342-49-035 - SERVICE BULLETIN

Title:	Introduction of an APU Fuel Leak Check				
lssue number:	002				
Issue Date:	16-03-2021				
Responsible Partner Company:		A0126			
Originator:		F1989			
Category:		2 – Highly Recommended			
Applicability:		In-service APUs with more than 3,000 cycles and equipped with at least one fuel line P/N 942006 (pre SB 342-49-026 configuration)			
Related SB:		342-49-034 and 342-49-026			
Related Documents:		None			
Accomplishment:		☐ Once only ☐ Recurring			
Planned to be incorporated in Technical Publications:					
	Safran Power U	nits PROPRIETARY INFORMATION

Figure 1: Identification of areas where the application of an absorbent is recommended

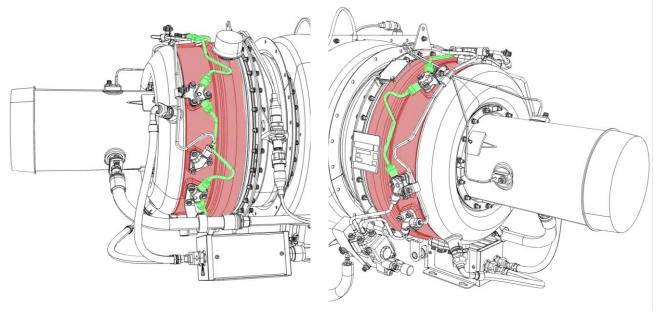
- 1. If the APU is installed in the helicopter, open the APU access doors 461A, 462A, 463A and 481A.
- 2. Clean the main burners manifold and the combustion casing with a cloth.
- 3. Apply an absorbent (e.g. talcum) over the main burners manifold and the combustion casing (see colored areas in Figure 1).

- 6. If the APU is installed in the helicopter, open the APU access doors 461A, 462A, 463A and 481A.
- 7. Inspect each pipe of the main burners manifold (in green on Figure 1) for fuel leaks.
- 8. If fuel leak is detected:
 - 8.1. Inform Safran Power Units (refer to para. 3.5.2).
 - 8.2. Replace the five fuel lines of the main burners manifold as per the instructions of the DMC 89-A-49-31-05-00A-520A-B and 89-A-49-31-05-00A-720A-B.

Figure 2: Location of the detected fuel leak

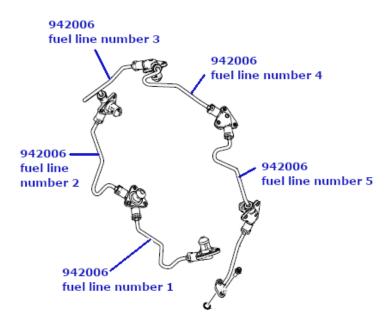
- Location of the leak (used the figure below and the fuel line number),
- Picture and/or video of the detected leak,
- Detail description of the finding,
- Specify if the fuel lines have been replaced due to the presence of the fuel leak.
